**AMERICAN FORK CITY
DEVELOPMENT REVIEW COMMITTEE AGENDA**

**Regular Session
March 23, 2026
Monday 9:00 AM**

- a. Review and action on an application for an Amended Site Plan, known as Navarro Home, located at 247 E 700 N, American Fork City. The Site Plan consists of 1.68 acres and is in the RA-1 Zone.

Review and action on an application for an Amended Site Plan, known as Navarro Home, located at 247 E 700 N, American Fork City. The Commercial Site Plan consists of 1.68 acres and is in the RA-1 Zone.

DRAWN MSS	CHECKED MEC	PROJECT # 25377
DATE 10/10/25		SCALE 1" = 10'
SHEET C103		ENGINEER'S STAMP

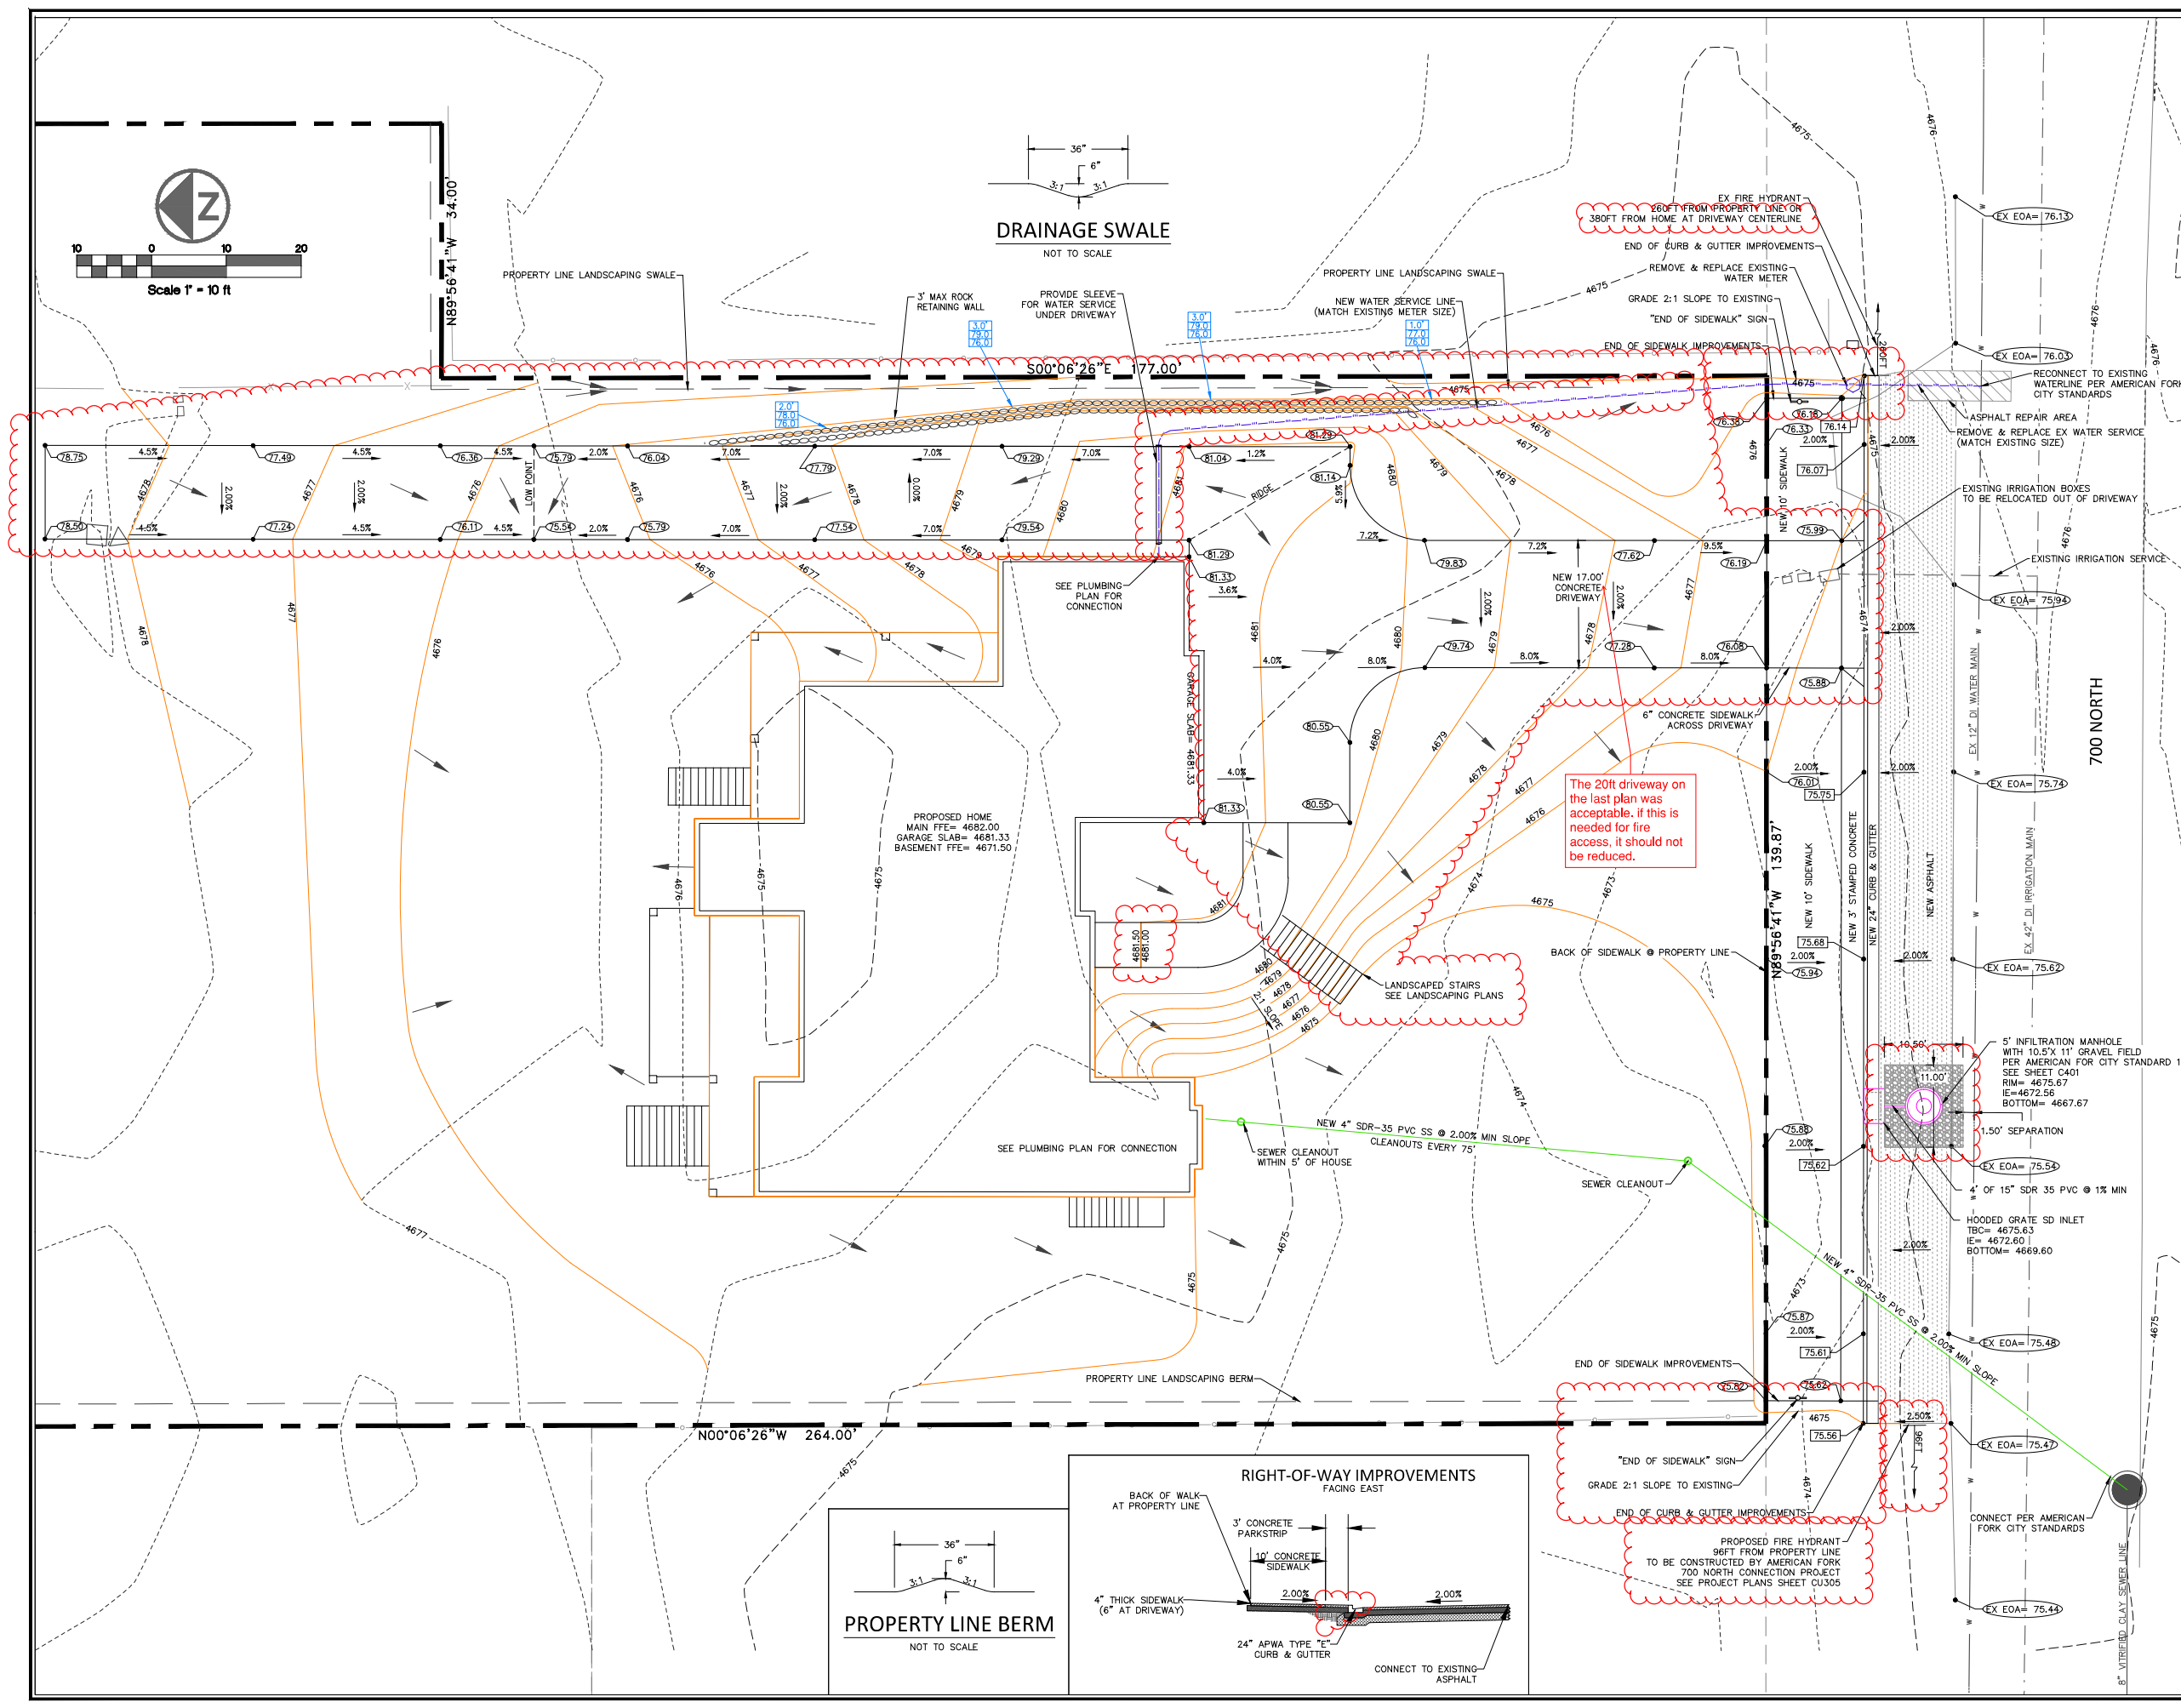
1. Fire department comment regarding driveway width will be addressed prior to building department approval. The driveway shall remain consistent with the previously reviewed design, maintaining a width of 20 feet, rather than the newly proposed reduction to 17 feet.

- One comment on changed driveway width
- No Comments
- No comments
